What is changing?

LHO 145, LHO 190, LHO 225

Clean-Out Tubes and Caps
through the Inner-Front

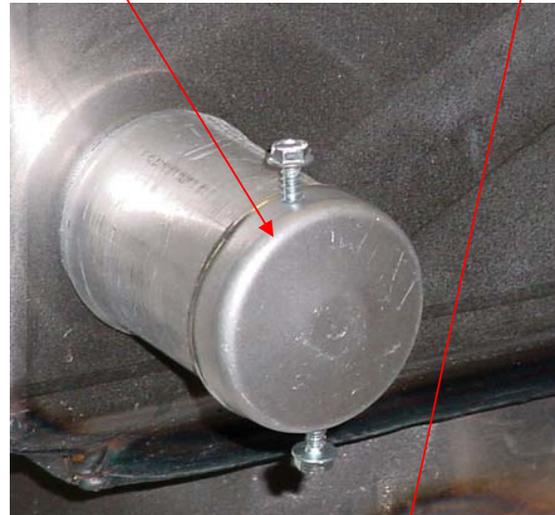
The Oil Furnace Heat Exchanger Clean-Outs will now be accessible through a tube that protrudes through the inner front of the furnace. The tube will have a gasket and cap secured by two screws.

In response to numerous customer requests the new design will allow direct access to the heat exchanger from the inner-front. The new design will eliminate clean-out covers and tools falling between the inner-front and the heat exchanger.
